UNITED STATES PATENT AND TRADEMARK OFFICE

| APPLICATION NO. | FILING DATE | FIRST NAMED INVENTOR | ATTORNEY DOCKET NO. | CONFIRMATION NO. |
|--|-------------|----------------------|---------------------|------------------|
| 10/680,070 | 10/06/2003 | Keith E. Myers | 816020-100046-US | 9949 |

Office Action Summary

DETAILED ACTION

FIG. 2

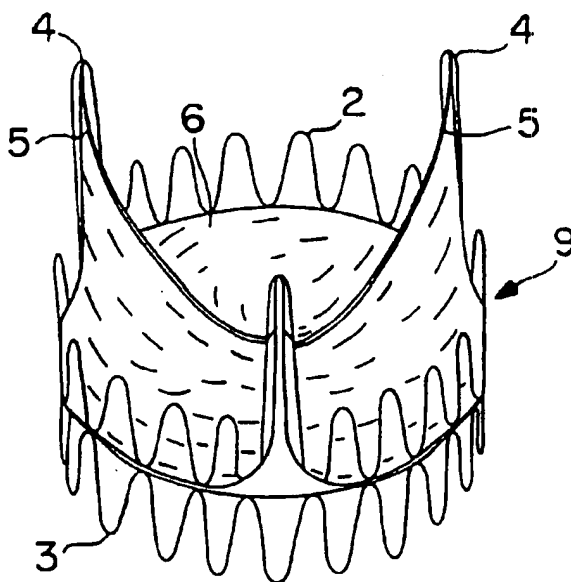
Claims 1, 3, 4, 7, 9, 10, 11, and 13 are rejected under 35 U.S.C. 102(e) as being anticipated by Andersen et al. (US 6,582,462 B1, cited in IDS). Andersen discloses an assembly (fig.2) comprising a valve (6), a collapsible and expandable anchoring structure (1) having three elliptical shaped elements (see three elliptical shaped elements in attachment 1), flared at each end (flared in fig.8, 9 shown to flare to the shape of the vessel) of the ellipse and joined side by side to form junctures (as seen in attachment 1). Andersen discloses support posts (4) having axial slots (seen in figs).
